**DECLARATION OF GREGORY ROWANGOULD, PH.D.**

**Review of the Albuquerque Rapid Transit (ART) Project's Potential  
Transportation and Environmental Impacts**

Prepared:  
June 8, 2016

Figure 1 Modeled Change in LOS from No-Build to Build Scenario (blue = increasing LOS, red = decreasing LOS)

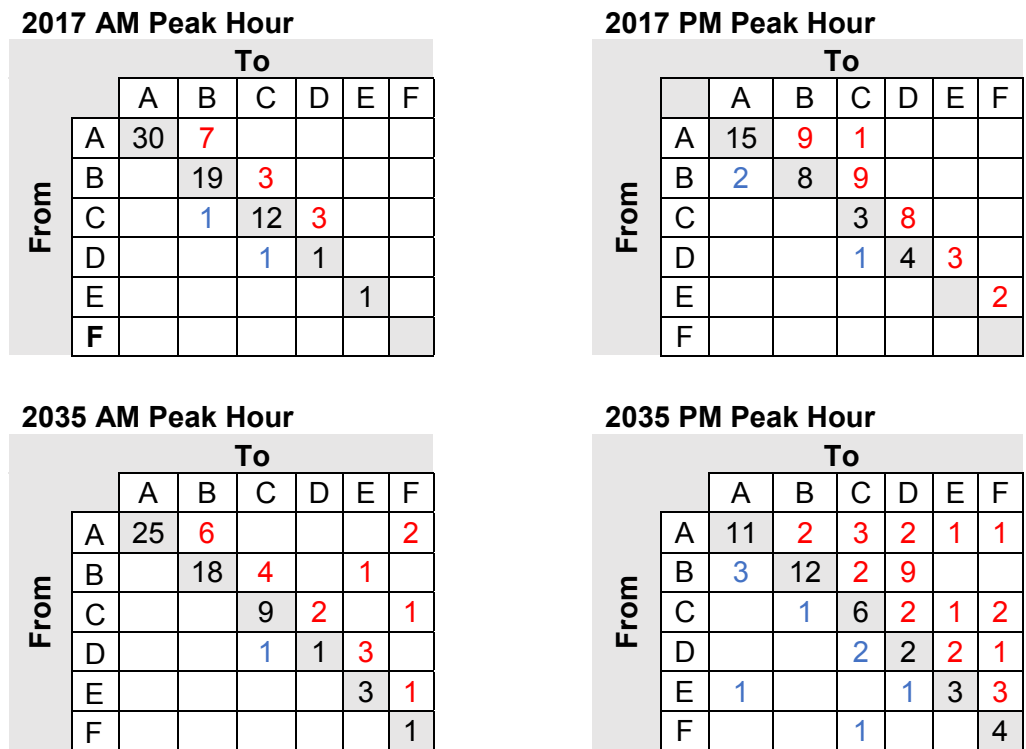
As shown in Figure 1, the traffic study demonstrates that the LOS of a large number of intersections will be degraded, rather than improved, by the ART project in its first year: LOS at 13 intersections will degrade during the AM peak hour and 32 will degrade during the PM peak hour. By the year 2035, intersection LOS in the project area declines for both the build and no-build scenarios because traffic volume is expected to continue growing over 2017 levels. However, the impacts are much worse if the ART is built than if it is not built: 20 intersections during the AM peak hour experience a reduction in LOS and 31 intersections experience reductions during the PM peak. These LOS reductions are also larger than in 2017. For example, in the AM peak period two intersections go from a LOS A without the ART to a LOS F with the ART, meaning that they will have gone from the best possible LOS to the worst. Intersections operating at a LOS of F along a busy corridor such as Central Avenue will likely become significant bottlenecks.

The ABQ Ride traffic study itself indicates that the ART project will significantly increase traffic congestion so it is difficult to understand how ABQ Ride could have answered "no" to this question. The traffic study finds that the ART project would cause deterioration in LOS at 13 intersections during the AM peak hour and 32 during the PM peak hour in its first year of operation. By 2035 intersection LOS in the project area declines for both the build and no-build scenarios because traffic volume is expected to continuing growing over 2017 levels; however, the impacts are much worse if the ART is built: 20 intersections during the AM peak hour experience reduced LOS and 31 intersections during the PM peak. These LOS changes are also larger than in 2017. For example, in the AM peak period two intersections go from LOS A without the ART, but to LOS F with the ART (see Figure 1 of this report).

ABQ Ride implies that there will be few, if any traffic impacts. ABQ Ride summarizes the 2017 results from the traffic study and states that during the AM peak hour *no* intersections will operate worse under the build scenario when compared to the no-build scenario<sup>68</sup>. This is simply untrue. The traffic study indicates that 13 intersections will operate at a lower LOS under the build scenario. This claim is not made for the PM peak where even more intersections will operate at a lower LOS (see Figure 1 of this report).
